CENPD-283-NP-A

Boiling Water Reactor Emergency Core Cooling System Evaluation Model:

Code Sensitivity for SVEA-96 Fuel

SAFETY EVALUATION BY THE OFFICE OF NUCLEAR REACTOR REGULATION
RELATING TO TOPICAL REPORT CENPD-283-P
"BOILING WATER REACTOR EMERGENCY CORE
COOLING SYSTEM EVALUATION MODEL:
CODE SENSITIVITY FOR SVEA-96 FUEL"

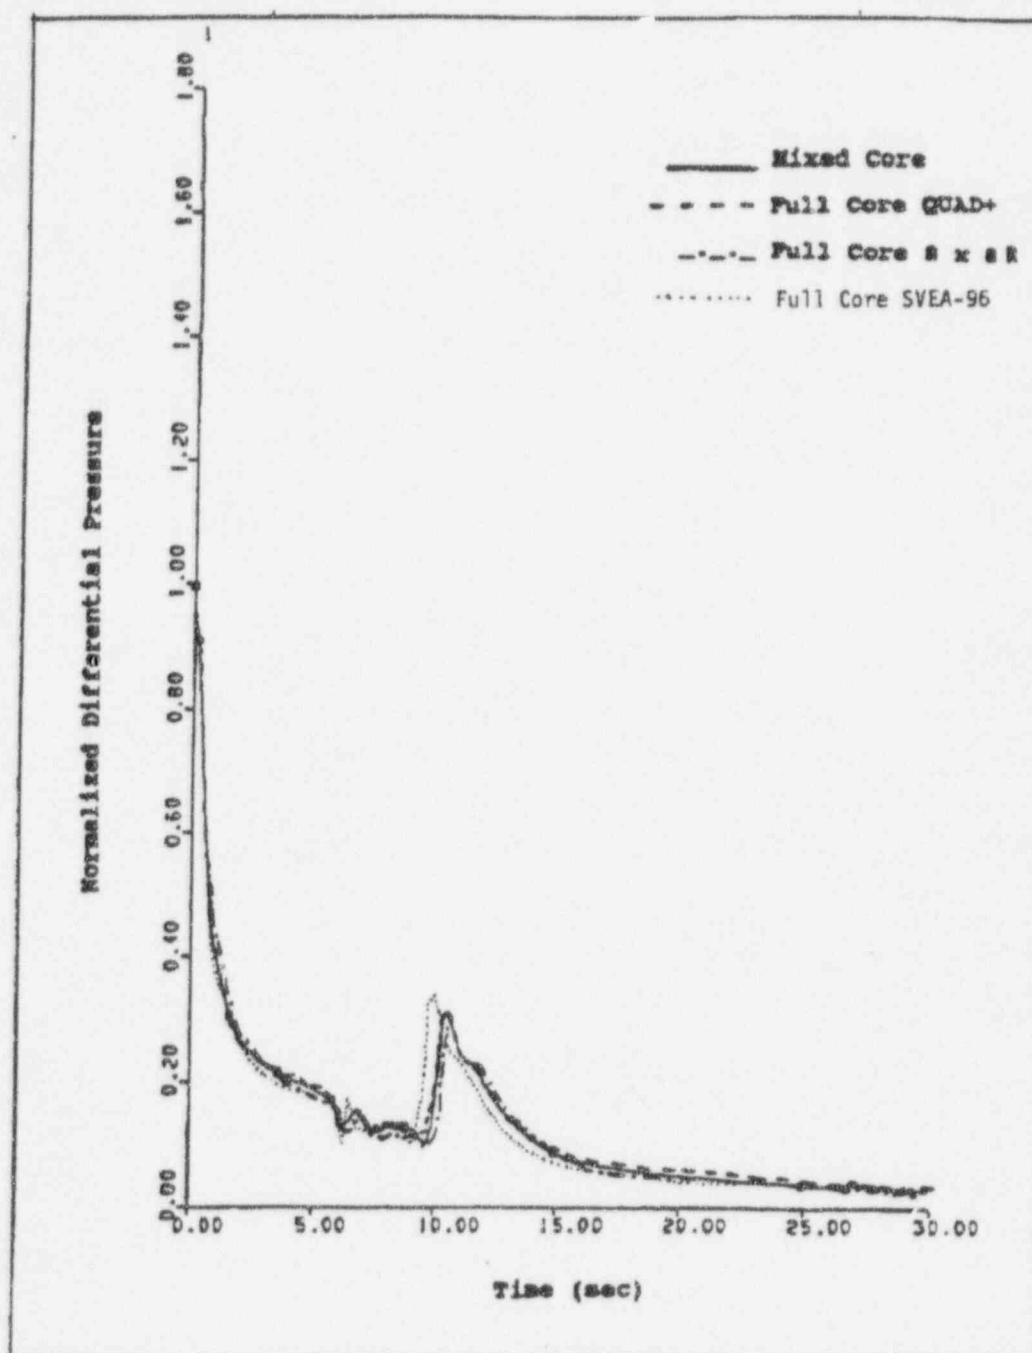
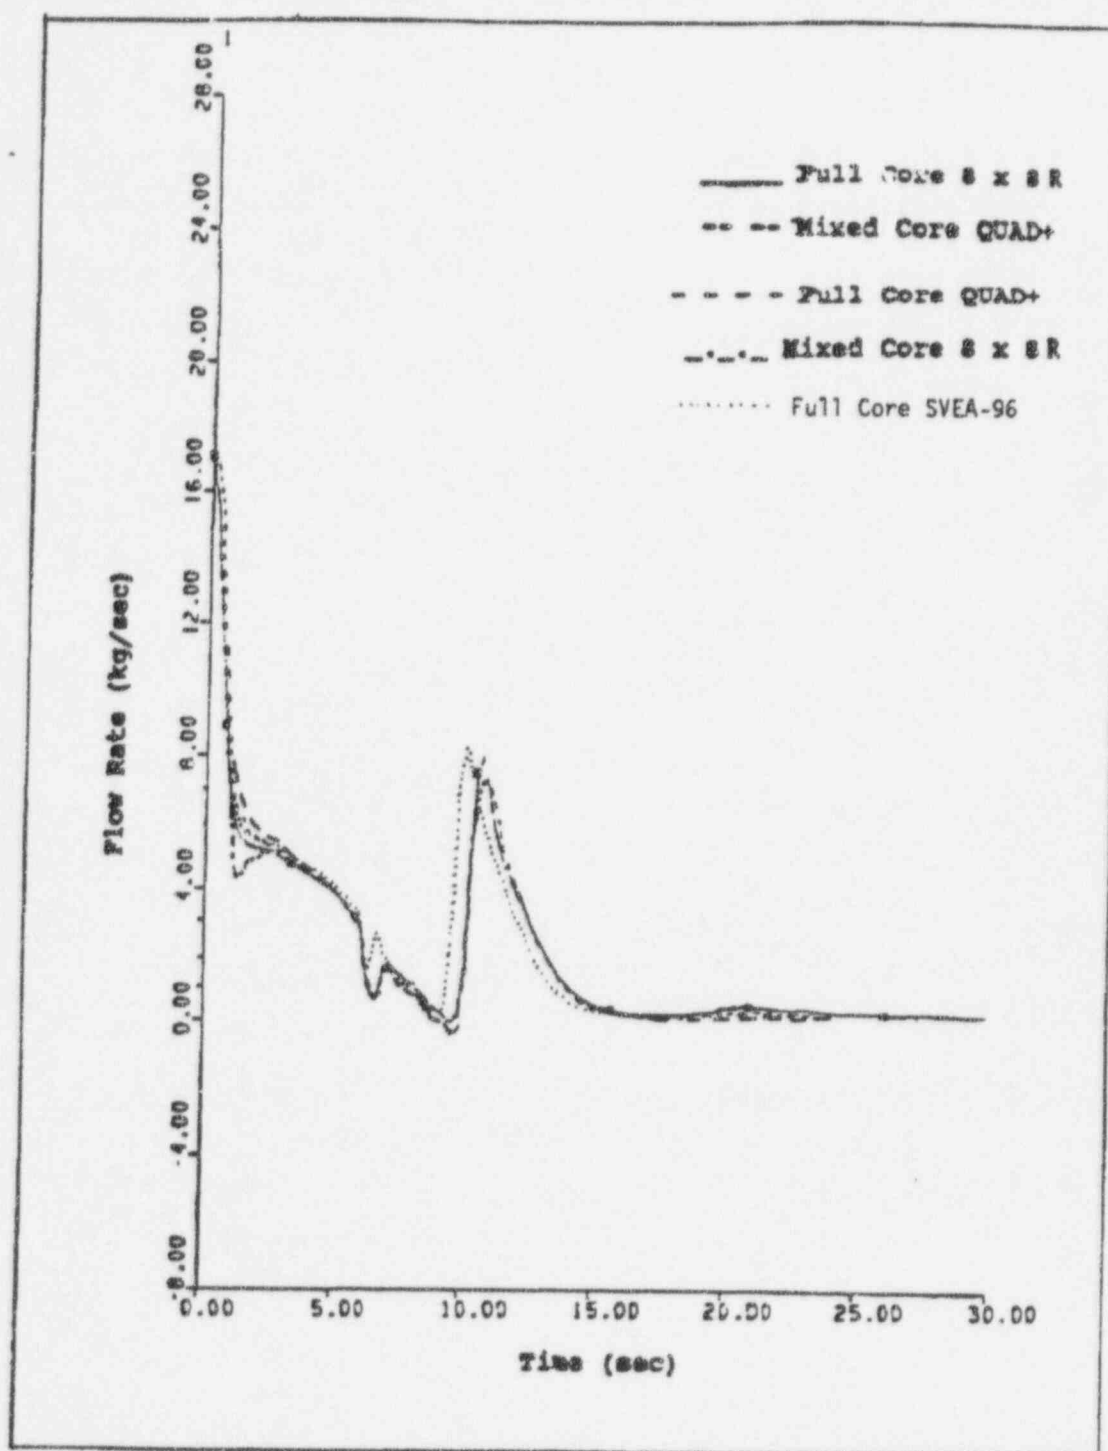
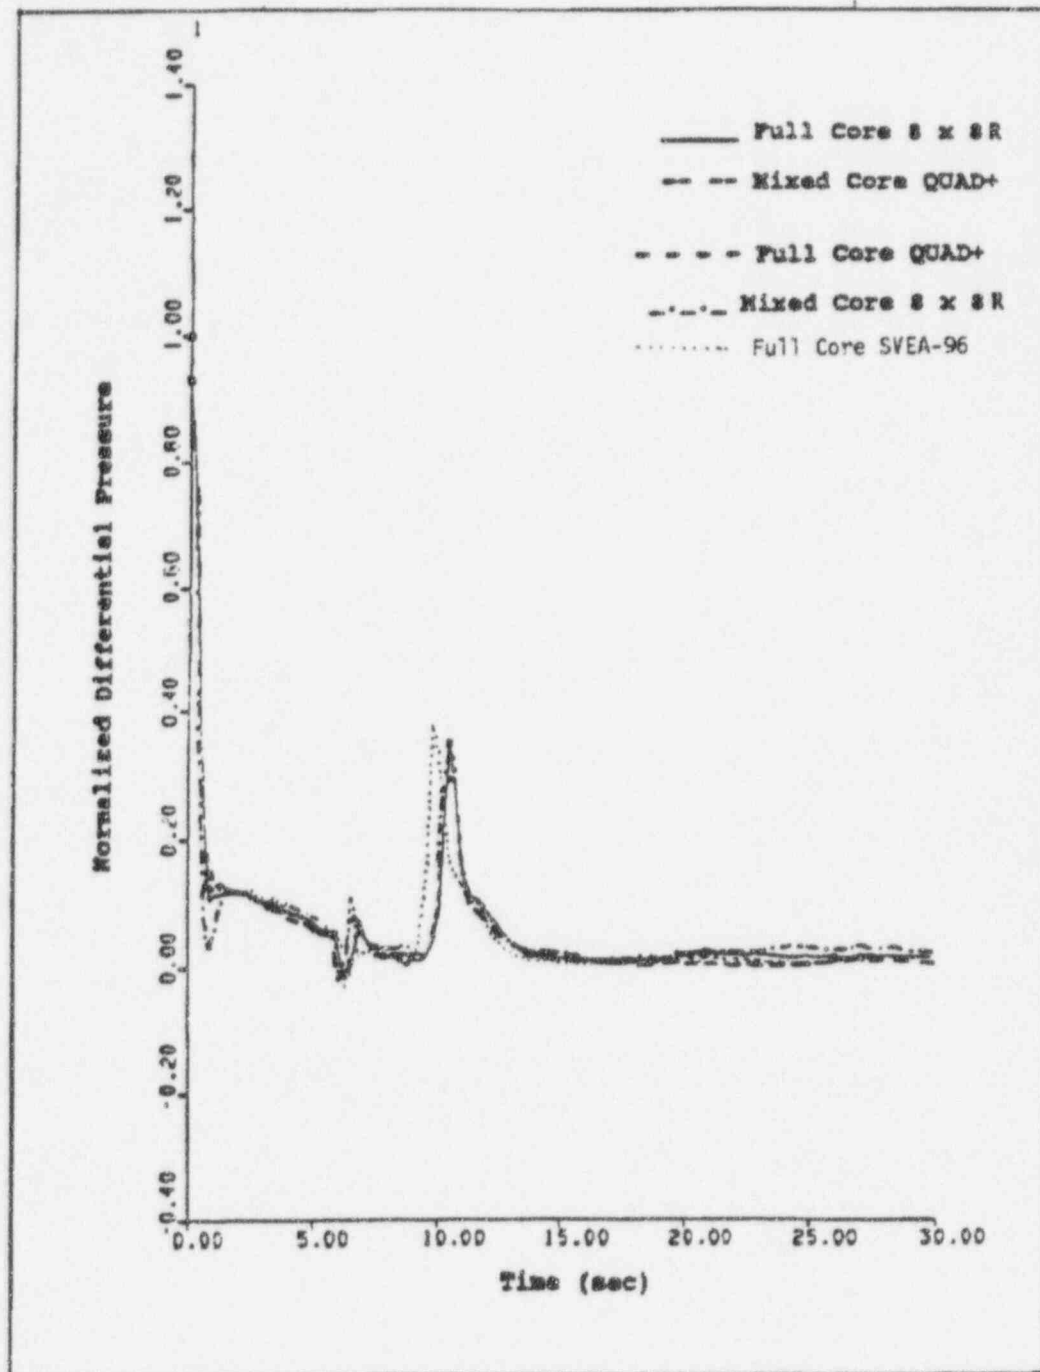
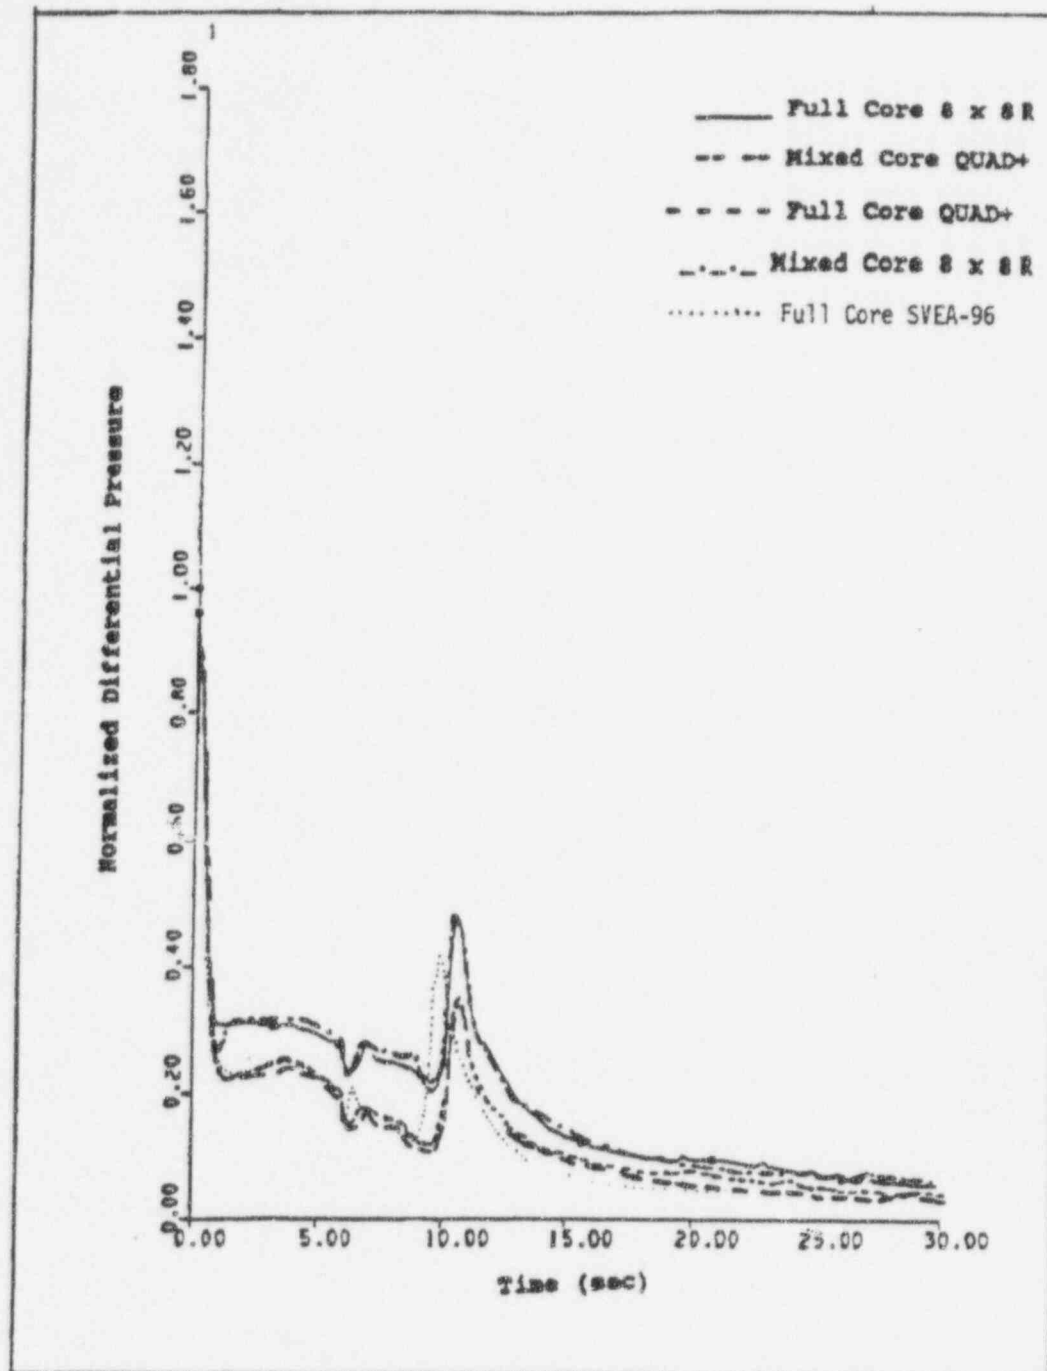
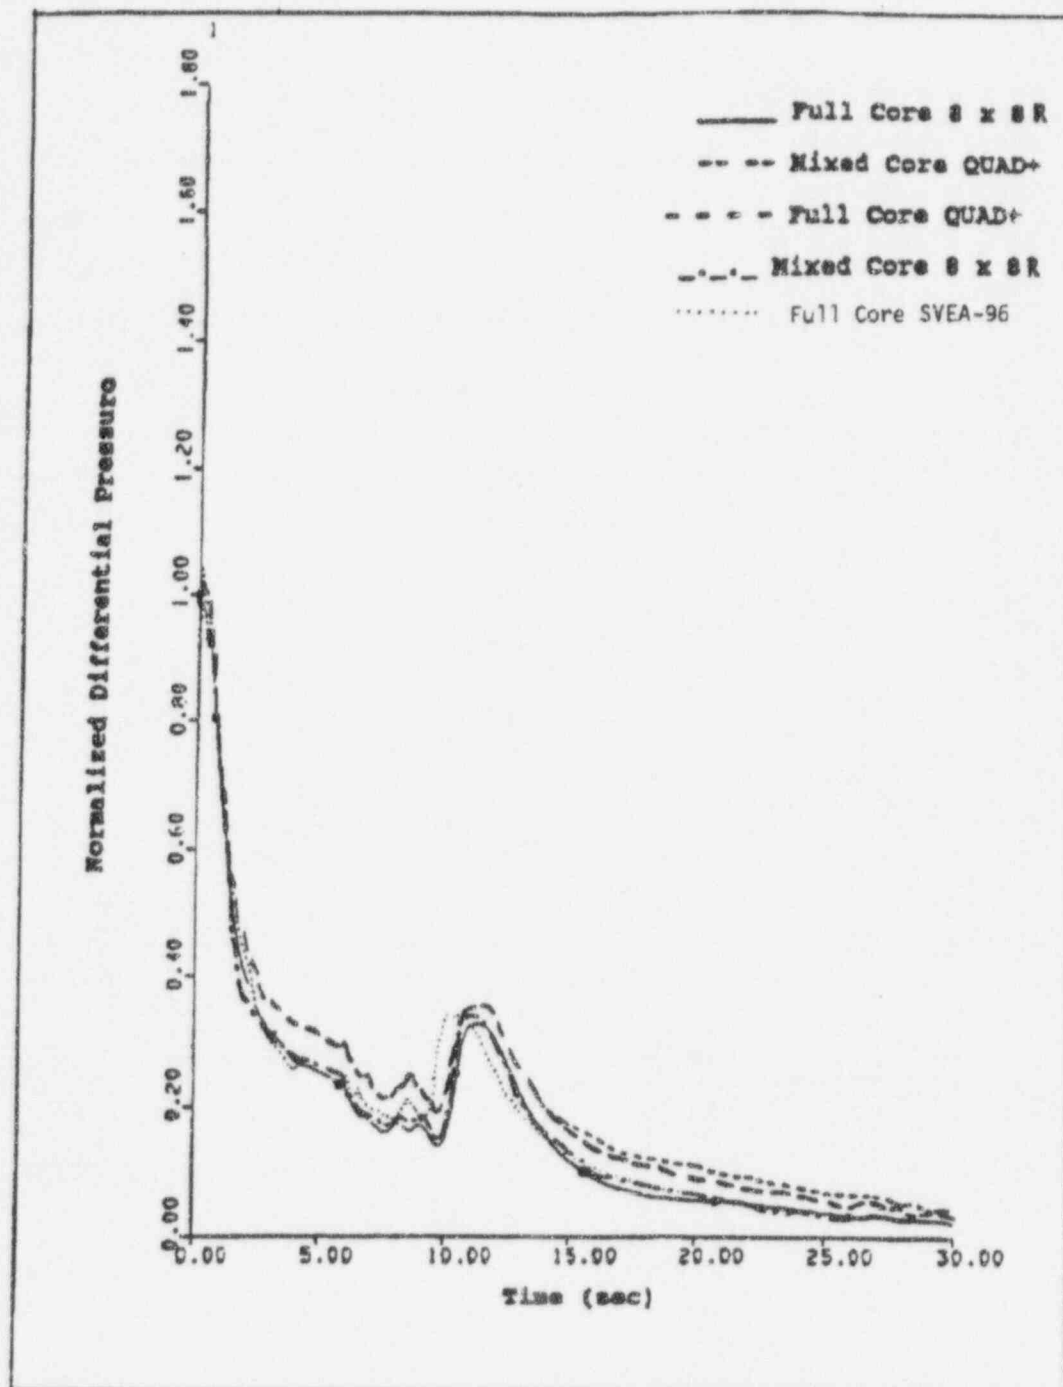
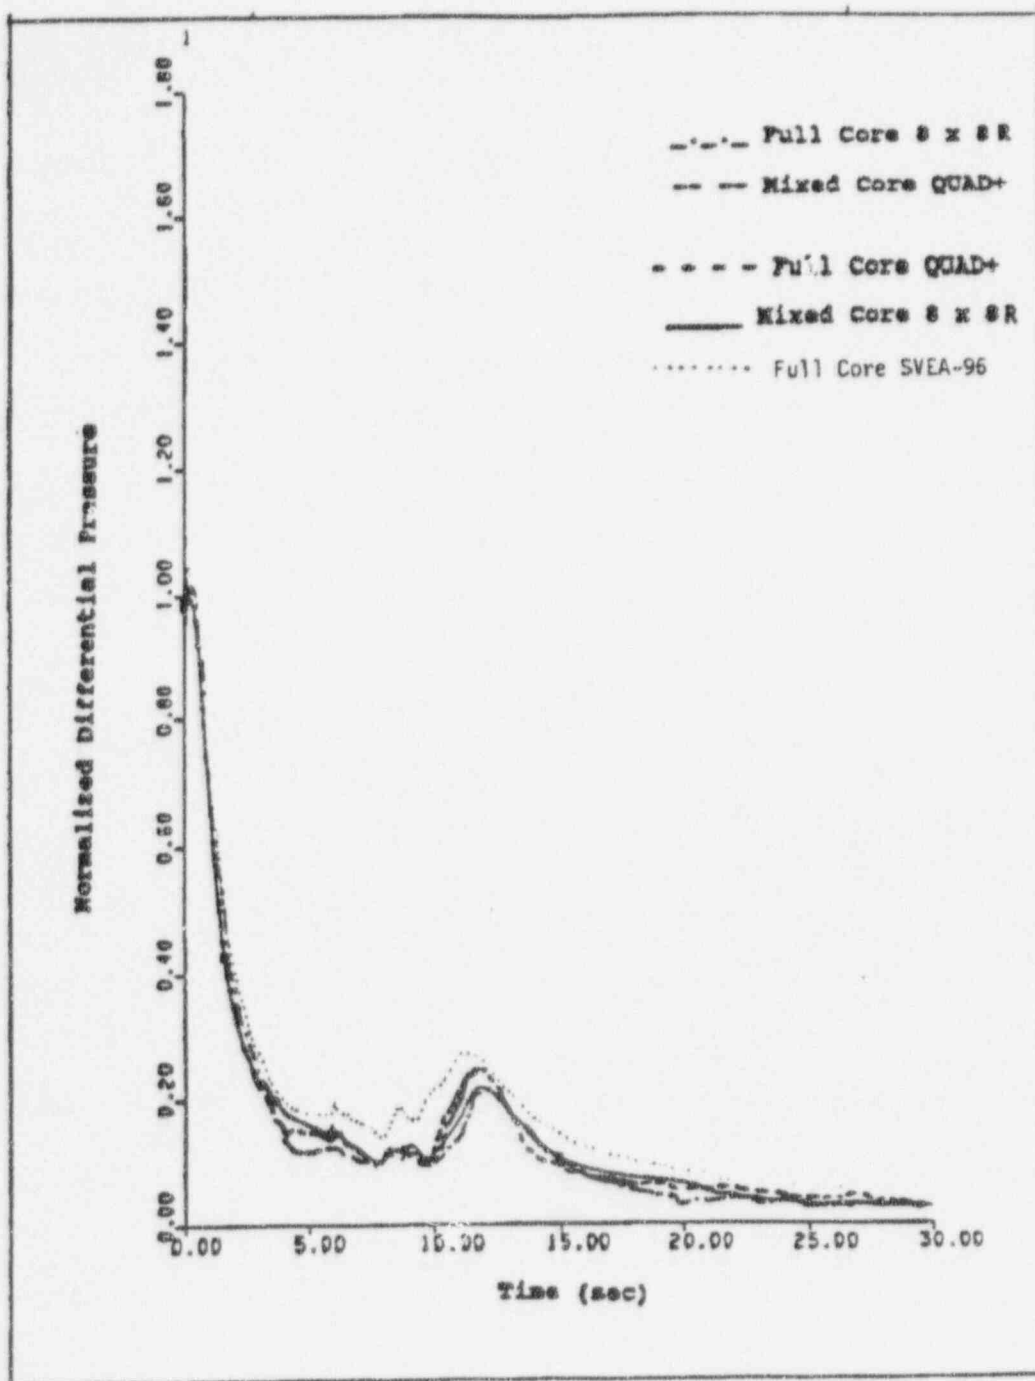
Mixed core effects should be investigated further to support ABB/CE's position regarding the transition cores by presenting mixed core analysis results with transition from QUAD+/SVEA64 fuel to SVEA-96 fuel. The watercross for each fuel design should be explicitly modeled in the nodalization. Provide plots from core void fraction, pressure, flow, and flow velocities.

To further demonstrate that the discussion presented and conclusions drawn in the response to Question 5 of RPB-90-94-P-A are valid in general, the results for a full core of SVEA-96 were compared to the previous system responses in Section 8 of this report. Additional comparative results are shown in Figures A9-1 through A9-8 which correspond to Figures 5-1 through 5-8 on pages 18 through 25 of the Addendum to RPB 90-94-P-A. The core compositions in the four cases presented in Figures A9-1 through A9-8 are:

For the Mixed Core case, as applicable, both QUAD+ and 8x8R channel results are shown in the figure. There are insignificant differences between the system responses of the four cores presented.

As discussed in Response 5 of RPB-90-94-P-A small differences in the responses are attributed to differences in fuel component designs. As noted in Response A1 of this document, the SVEA-96 core used as an example was not specifically designed to be hydraulically comparable with the previous example cores (i.e., QUAD+ and 8x8). Hence, in some instances in Figures A9-1 through A9-8, the SVEA-96 results deviated slightly more than those observed for the other cores configurations. However, the overall system responses are very similar.

The results presented here further substantiate the general conclusion that the core average system response is relatively independent of local differences in fuel assembly design.
